Subject: Adjustment of the water ballast actuation inside the fuselage
Serial number applicability: All ASW 28

Fig. 1

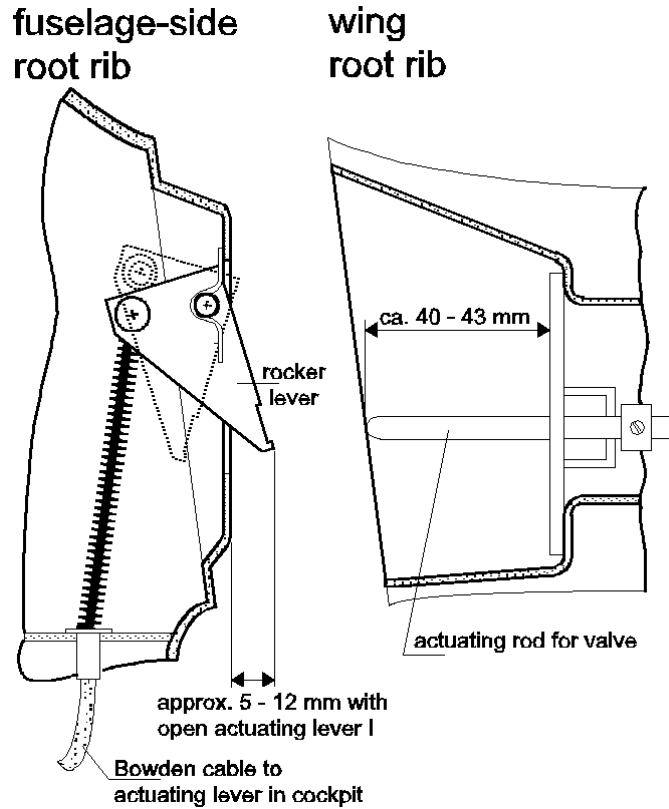
Reason: In case that the water ballast valves in the wings drain uneven or do not open fully, their actuation may be checked and adjusted according to the following instructions.
Badly adjusted actuation systems may be the cause that the rocker switch in the fuselage misses the actuating push rod by running over it during rigging and so the valve inside the wing cannot open.

Action: As shown in Fig. 1, the correct adjustment of the valve actuation can be easily checked.
The adjustment of the actuation system is done at the rocker switch by turning the lock nut at the threaded connector into or out of the Bowden cable (see Fig. 2).
